PREDETERMINATION SETTLEMENT AGREEMENT

CP# 09-19-73968
HUD# 07-19-2743-8

Subject Property

Figure 1

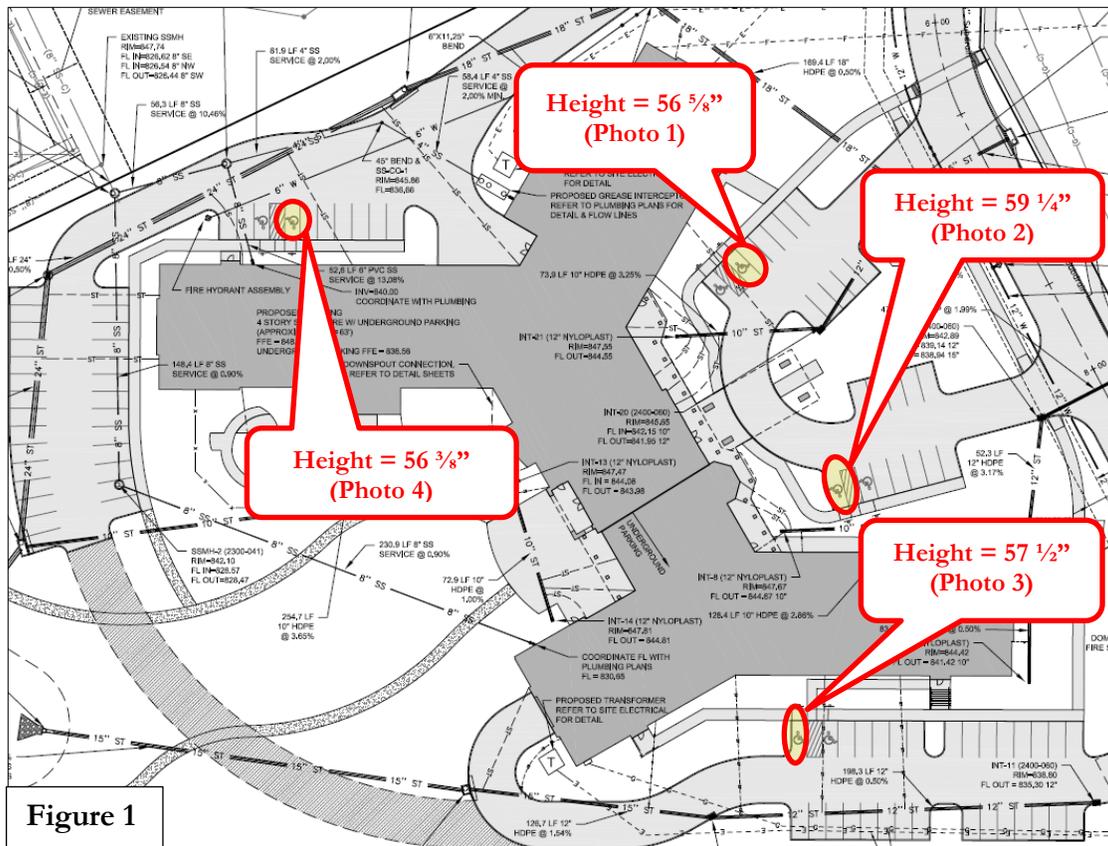
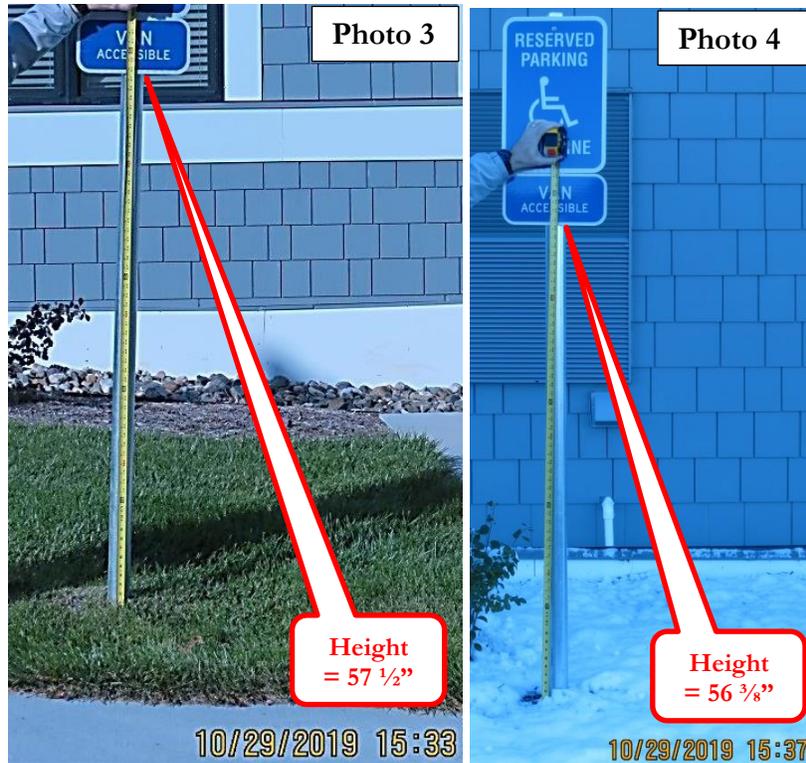
- 1) The following screenshot (*see* Figure 1) is taken from the site plans, which has been captioned to indicate the location of the measured heights of the signage.

ICRC Investigators measured the height to the bottom edge of the sign at the parking spaces described in above at heights ranging from 56 ³/₈" to 59 ¹/₄"– which are all less than the 60"-minimum height required in Section 502.6 from the 2010 ADAAG. ICRC took the following photographs (see Photos 1, 2, 3, and 4) to document their measurements:

The plans required the signage to be installed at a height of no less than 60”, as measured to the bottom edge of the signage. If the signage had been installed consistent with the designed minimum height, it would have been compliant with the 60” minimum height requirement. However, as installed, the signage – at the inspected parking spaces designated as reserved for use by persons with disabilities – are too low, which make the spaces more challenging to locate by persons with disabilities.

- 1) Respondents state they have reinstalled the signage designating parking spaces to increase the height of 60” as measured to the bottom edge of the signage. Respondents have submitted photographs to document compliance.
- 2) Respondents state they have either raised the carpet to decrease the vertical height at the interior threshold of the sliding glass doorway to less than 1/4” or installed a 1:2 bevel to correct threshold heights

1) ICRC has reviewed the photographs submitted by Respondents and agrees with their claim that these photographs support their claim that they reinstalled the signage designating parking space that serves the leasing office to increase its height to no less than 60” as measured to the bottom edge of the signage. ICRC does not require further action from Respondents to correct this deficiency.

Photo 6

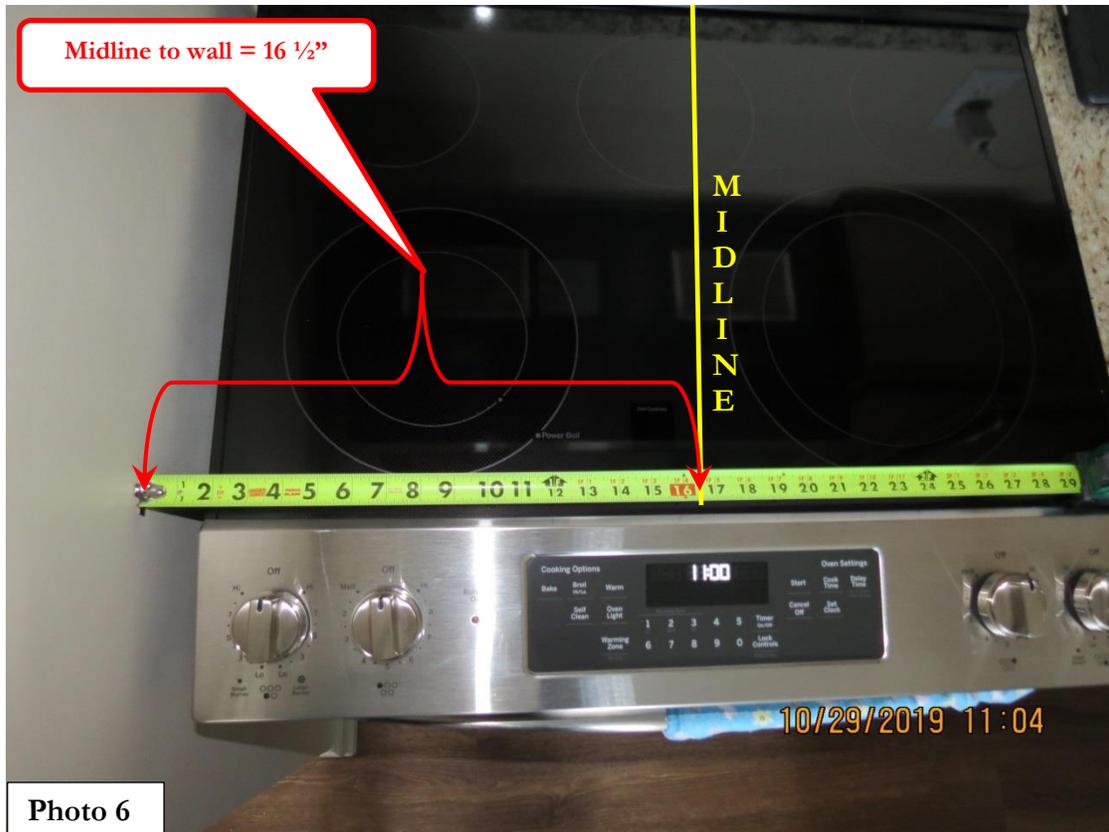
4) The midline of the range in Unit 118 [1BR-1A] was measured to be $16\frac{1}{2}$ " away from the left wall – which protrudes $6\frac{1}{2}$ " in front of the range – and which is less than the 24"-minimum required. ICRC Investigators took the following photograph (*see* Photos 6 and 7) to document their measurement:

The front face of the wall adjacent to the range was designed to be flush with the front face of the range, which would have allowed for the 48" side of the required clear floor space to be centered on the

midline of the range that is necessary for the parallel approach by a person using a wheelchair. If this wall had been installed consistent with the specifications in the plans, it would have been compliant with the 24”-minimum of clear floor space that is required on both sides of the midline of the range. However, as built, this wall is too close to the midline of the range – which makes the range unusable by persons who have a mobility impairment and use a wheelchair.

3) Respondents state they have modified the wall adjacent to the left of the range – at the 45 units they have identified as requiring this retrofit – by cutting it back so that the front face of the wall is flush with the front face of the range – as was completed at Unit 213 – and create a 30”-by-48” clear floor space centered and flush with the front face of the range.

3) ICRC has reviewed the photographs submitted by Respondents and agrees with their claim that these photographs support their claim that they have modified the wall adjacent to the left of the range – at the 45 affected units – by cutting it back so that the front face of the wall will be flush with the front face of the range and create a 30"-by-48" clear floor space centered and flush with the front face of the range. ICRC does not require further action from Respondents to correct this deficiency.
